Amendments to the Drawings:

REMARKS

FIG. 1
(PRIOR ART)

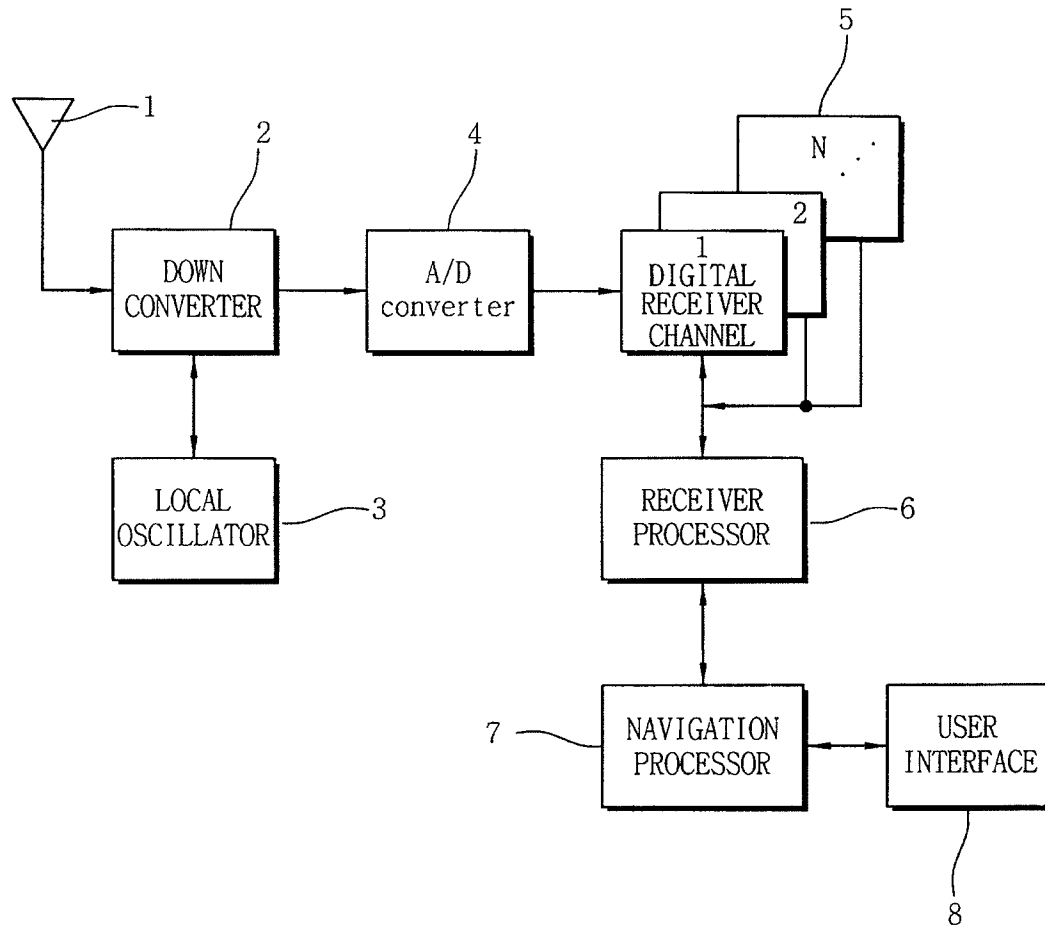
Figures 1 and 2 have been objected to for failing to include a legend designating the figures as “Prior Art.” Accordingly, replacement sheets including the requested legend are attached to this Amendment.

The attached sheets of drawings include Replacement sheets for Figs. 1 and 2. These figures have been changed to include a legend designating the figures as “Prior Art.”
